The City of Norman, Oklahoma

## Historic District Commission Certificate of Appropriateness

REQUESTING THE FOLLOWING AMENDMENTS TO THE PREVIOUSLY APPROVED COA 24-08 AND 25-04:

W.W. HOUSE  
 1320 Oklahoma Av. Norman OK 73071

# NORTH ELEVATION - OLD

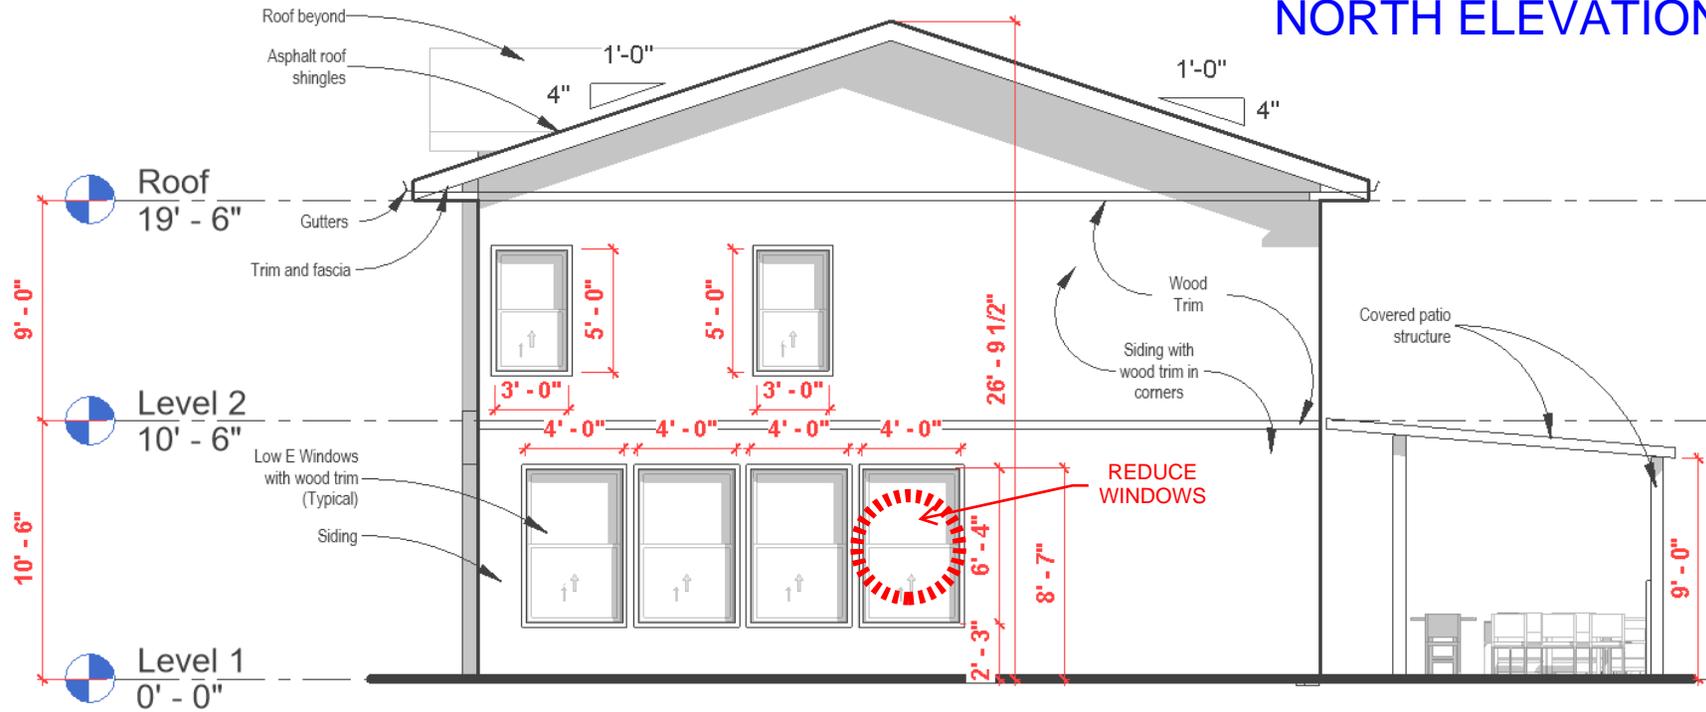
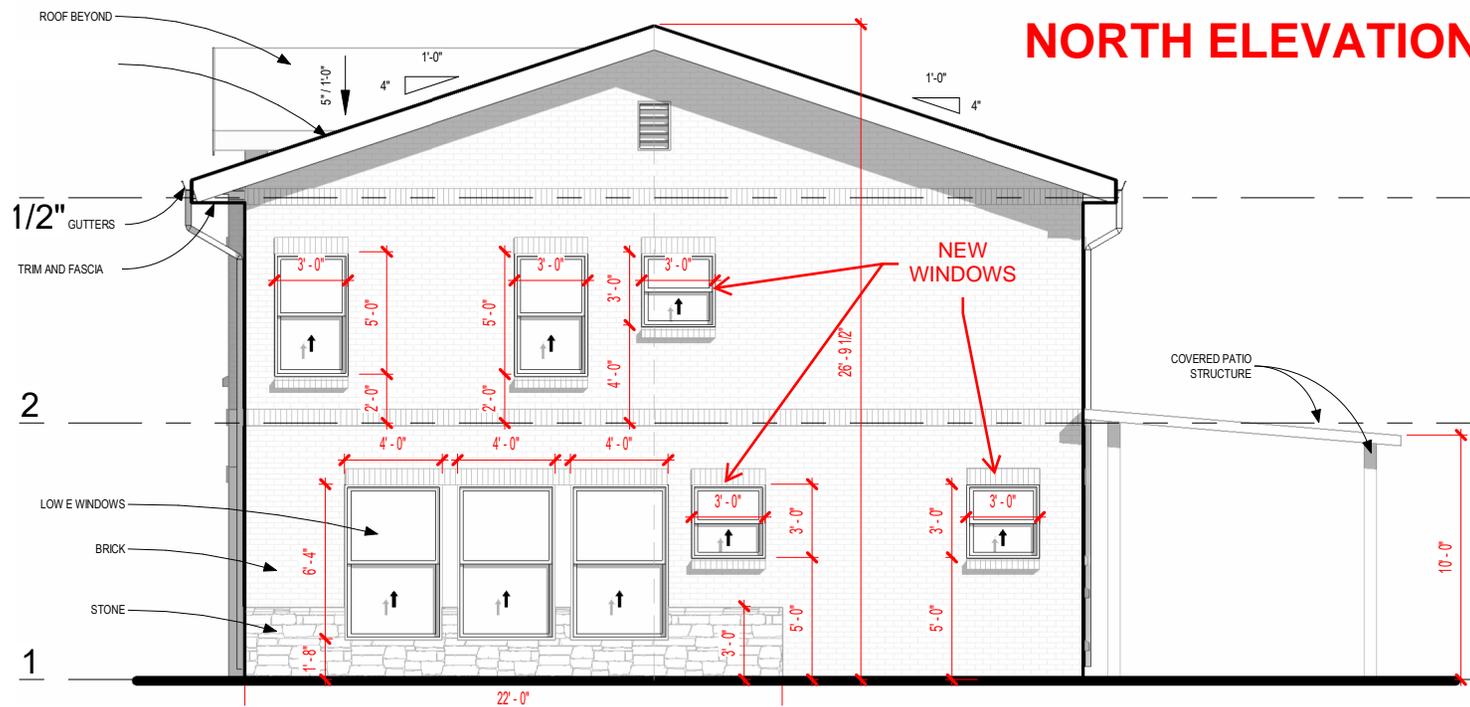
**+ ADDED 3 WINDOWS  
+RE-ORGANIZE OPENINGS  
+SELECTIVE SIZE CHANGES**

# 8- Removal of ADU

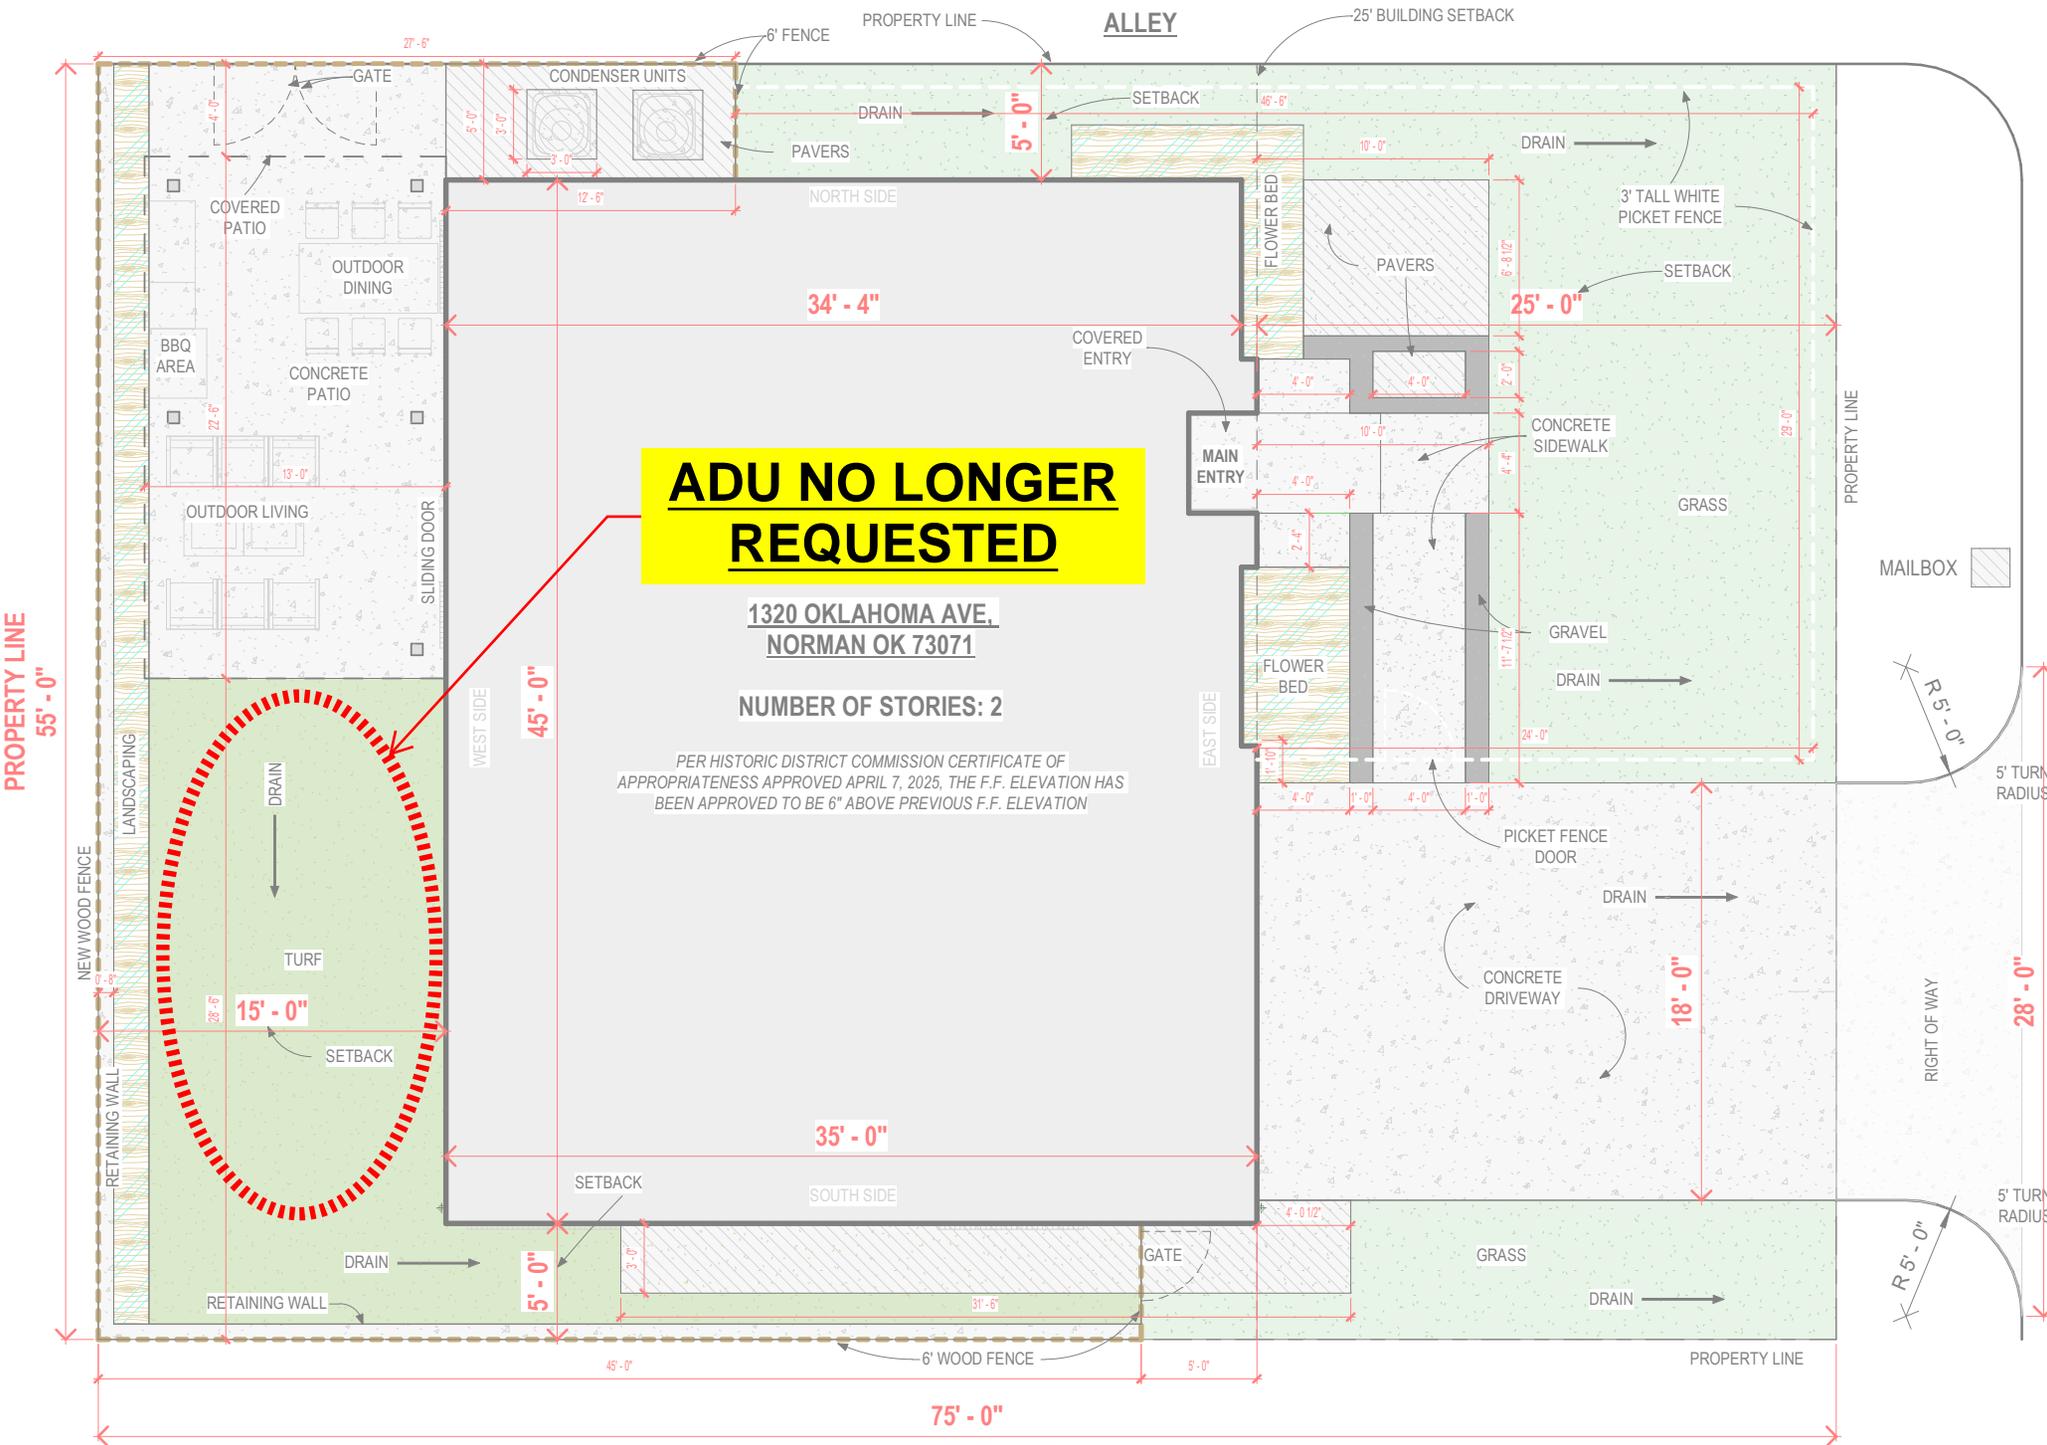
**ADU NO LONGER REQUESTED**

## 9- Request new picket fence

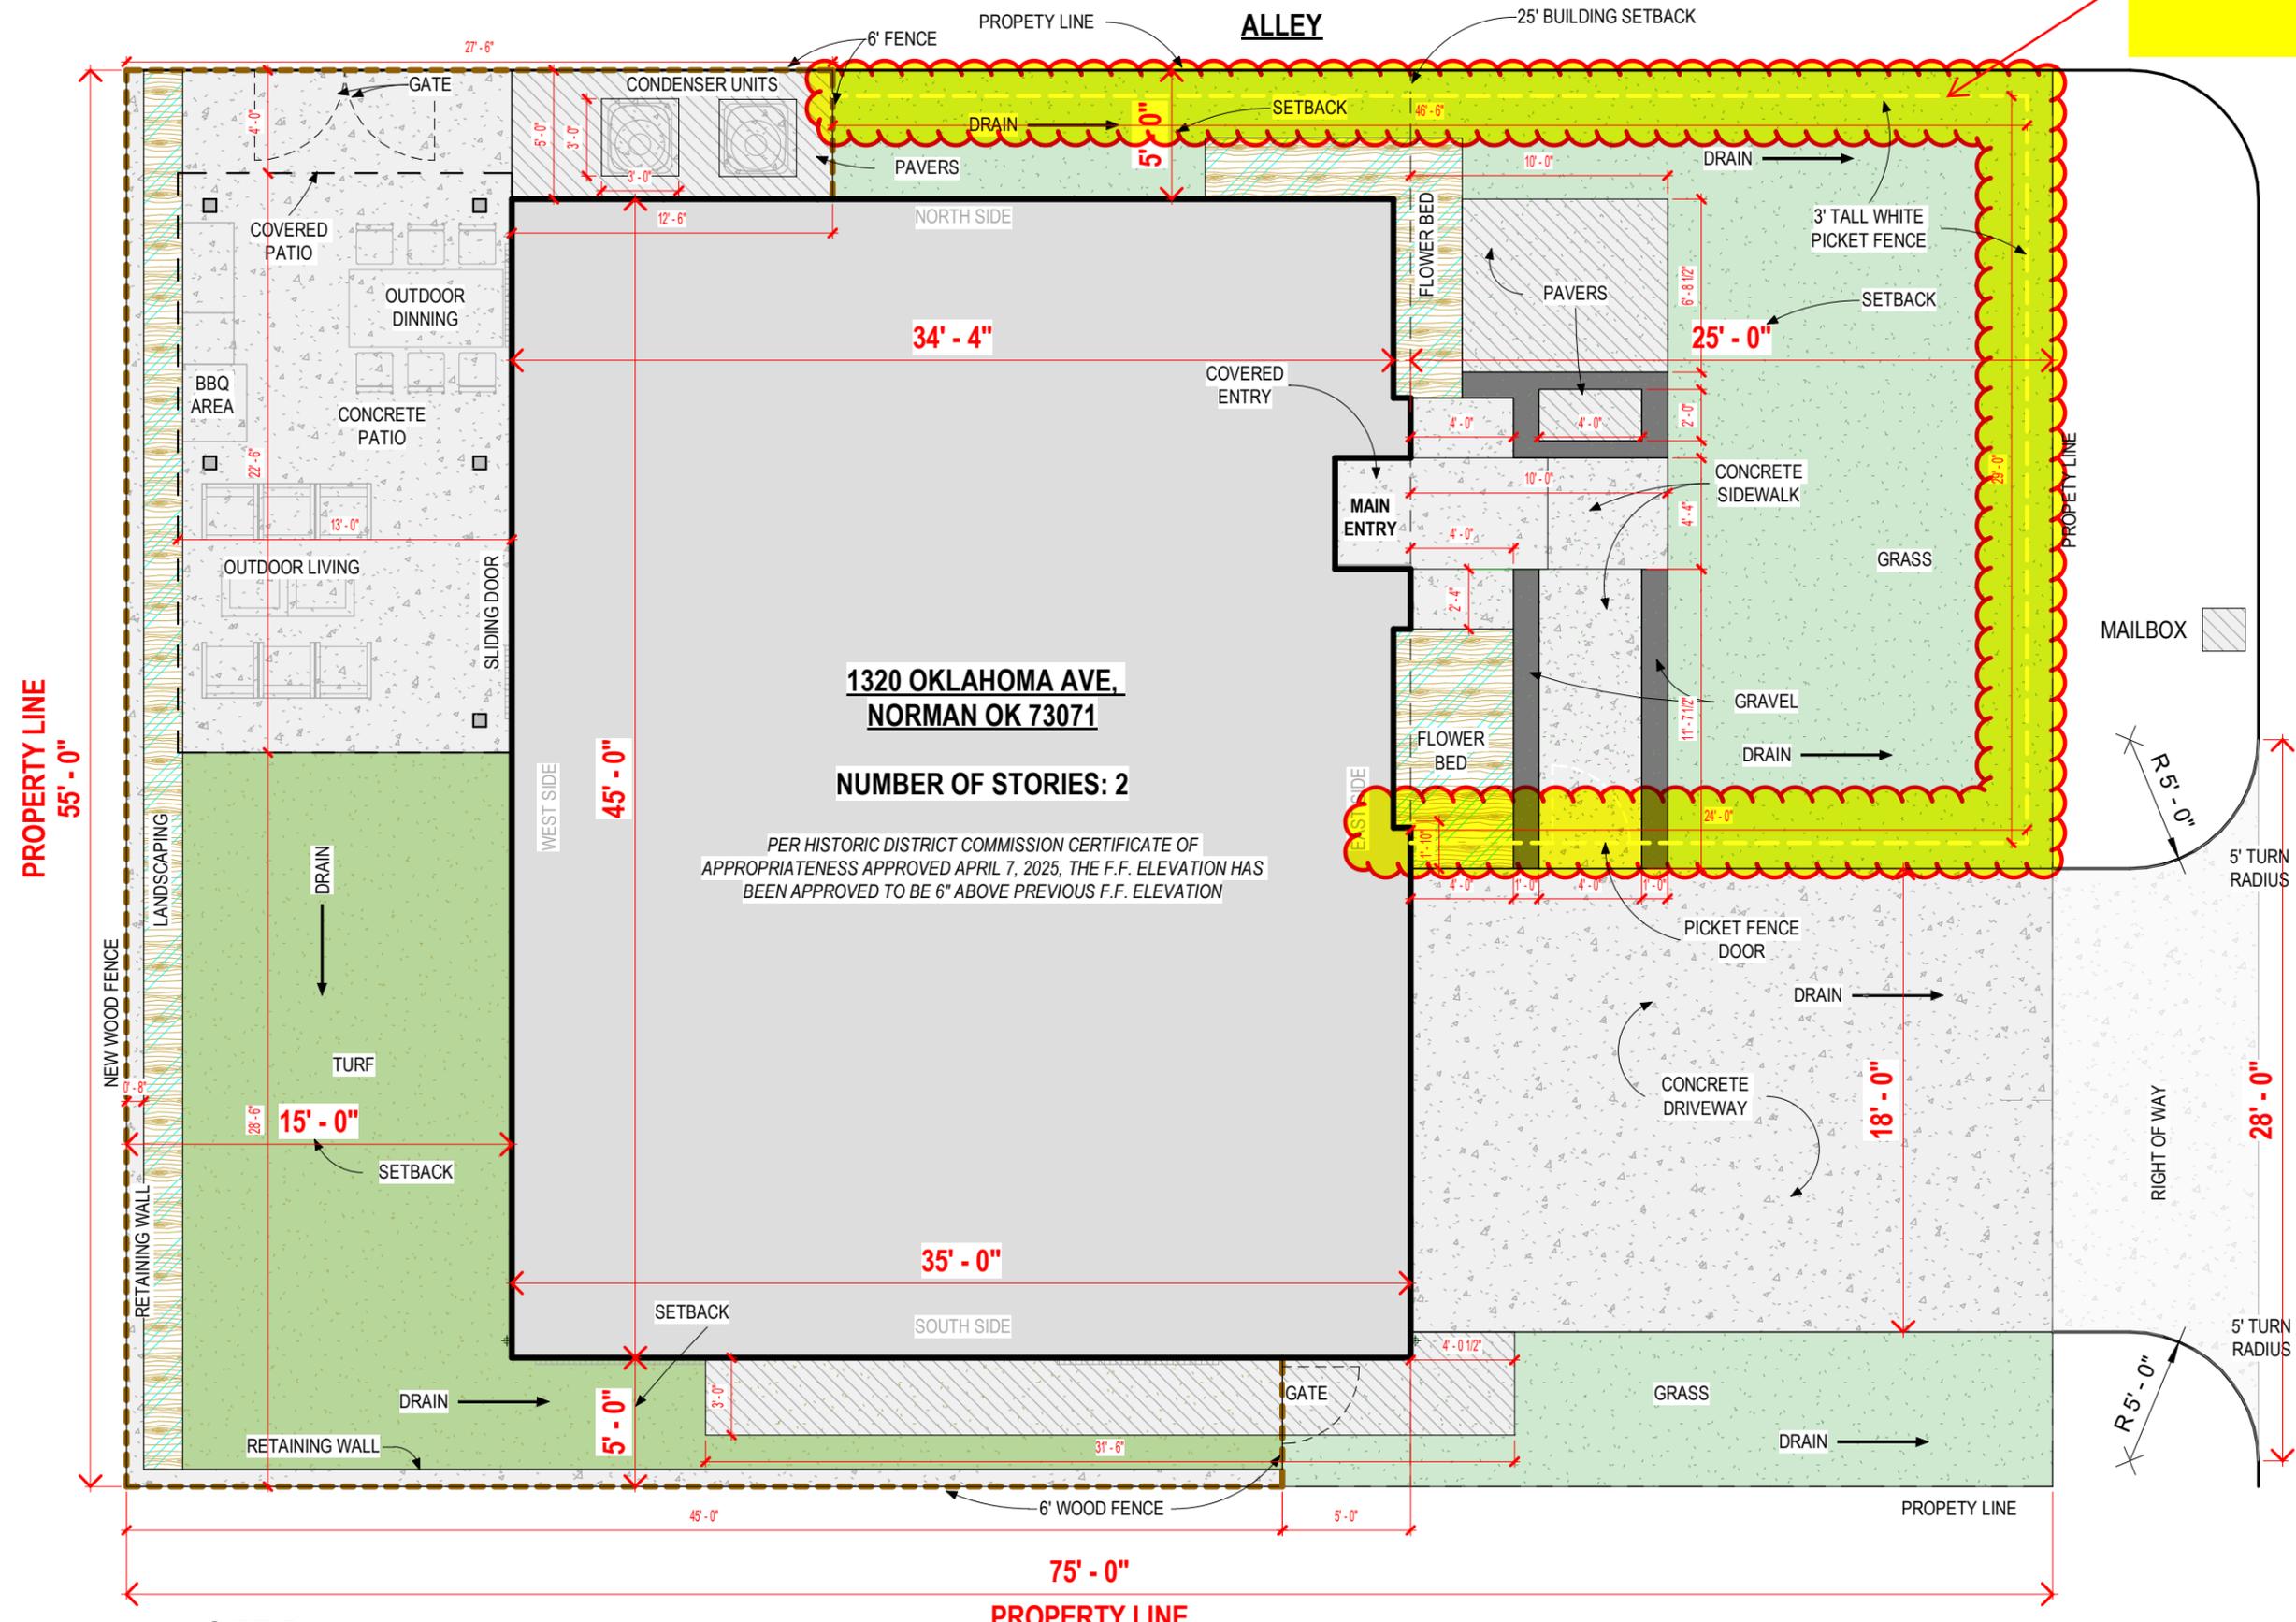
**Total Length= 99'-6**

**Total Height= 3'-0"**

# NEW WHITE PICKET FENCE
